UNIRAIL / ROOFSAFE CARRIAGE - PRODUCT RETROFIT NOTICE

22 February, 2016

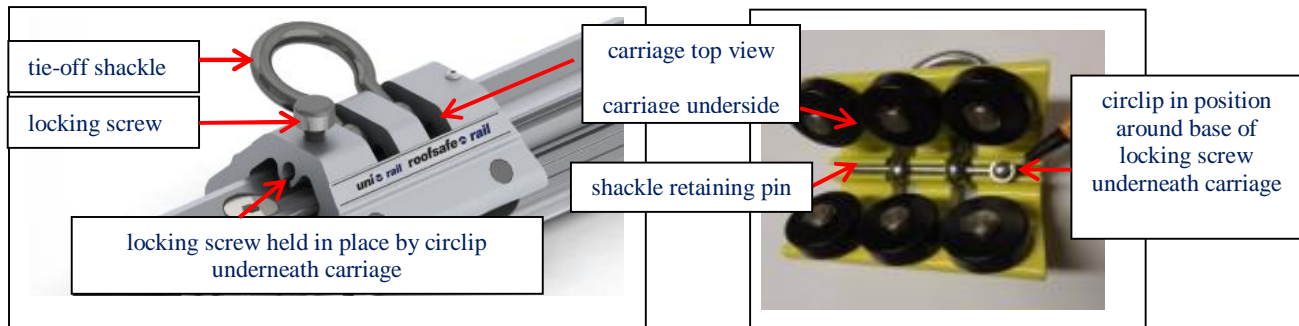
The UniRail[®] and RoofSafe[®] Rail Systems are lightweight, modular, horizontal rail systems that provide a moveable anchorage point for workers at height. Tie-off capability is provided via a tie-off shackle incorporated into the carriage component of the system as pictured below. These systems can be installed at any working level, from foot level to overhead.

Capital Safety has received a limited number of reports of fractured circlips (the locking screw retaining clips) which can allow the locking screw to unscrew and separate from the carriage body. If the locking screw separates from the carriage body, it is possible for the shackle retaining pin to slide out of the carriage body and release the tie-off shackle. We believe that user practice of permanently backing the locking screws out to allow the carriage to move freely on the rail can overload the circlips to the point of fracture over time. Only UniRail / RoofSafe carriages manufactured before February 2015 are susceptible to this condition.

There have been no reports of these systems failing to arrest a fall. However, in certain applications (e.g., overhead installations), if the shackle separates from the carriage body, it is possible that other fall protection equipment connected to the shackle (such as a self-retracting device), may fall and cause bodily injury or property damage. Accordingly, Capital Safety has developed a fixed-bolt Retrofit Kit to replace the locking screw and circlip.

NEXT STEPS: Capital Safety recommends that all users of UniRail/RoofSafe carriages manufactured before February 1st, 2015 install a Retrofit Kit. **Note, this is not a product recall.**
